**Revised Quarry Restoration Scheme Incorporating
Tunnel Arisings from the Haweswater Aqueduct
Resilience Programme (HARP) Namely the
Bowland and Marl Hill Tunnel Sections.**

Planning Application LCC/2021/0015

Waddington Fell Quarry

Supplemental Submission

Drawing 300461-001 Rev A

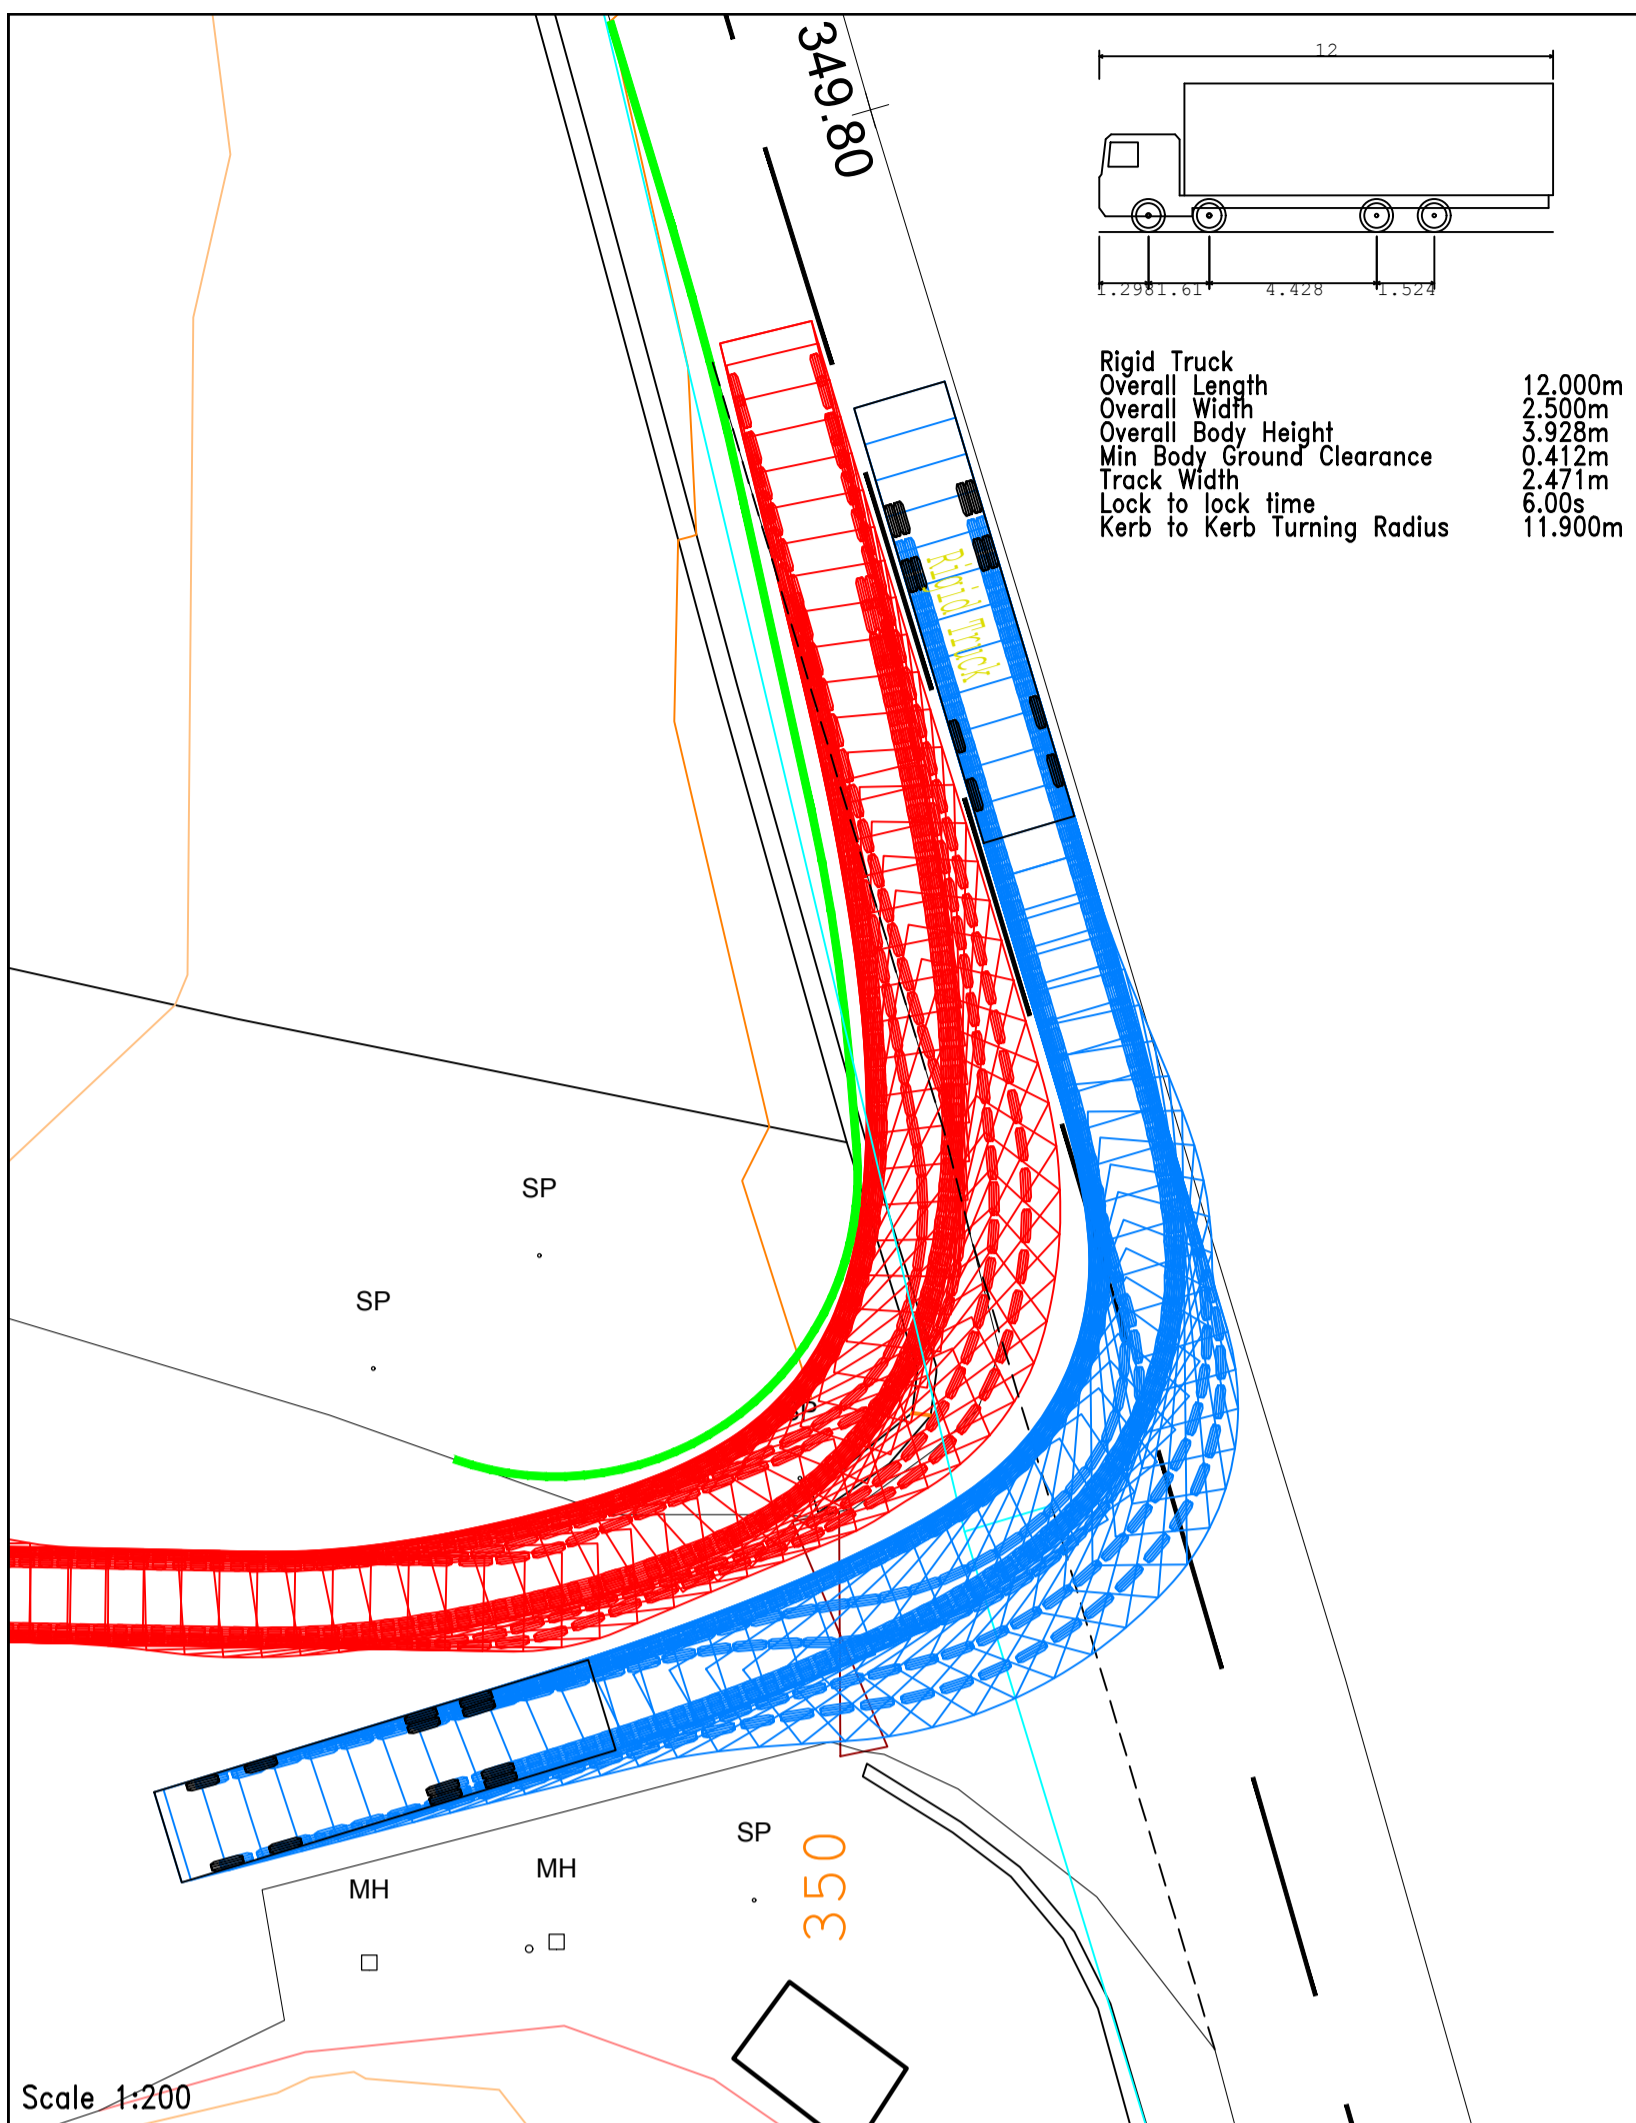
1. *The existing access arrangements are not adequate for the proposal, that will see significant HGV movements to and from the north. Our initial review of ordnance survey maps suggests that the layout, turning radii and width of the existing access cannot accommodate HGV movements in and out of the Quarry simultaneously. These movements must be accommodated to ensure that HGVs are not waiting on the carriageway to access the Quarry, especially during the simultaneous tunnel bores. An improvement scheme at the access, widening the Quarry entrance and improving turning radii to the north is necessary. When the improvement scheme is developed, we would expect to see the site access layout with the swept path analysis and visibility splays.*

Drawing 300461-001 Rev A at **Appendix A** illustrates a preliminary 2D design and includes swept path analysis of a 12m rigid vehicle accessing and egressing the junction in both directions. The drawing demonstrates that vehicles would not need to wait within the highway to access the site.

Drawing 300461-001 Rev A shows that the required stopping sight distances can be achieved from the centre of the proposed site access from an x-distance of 2.4m.
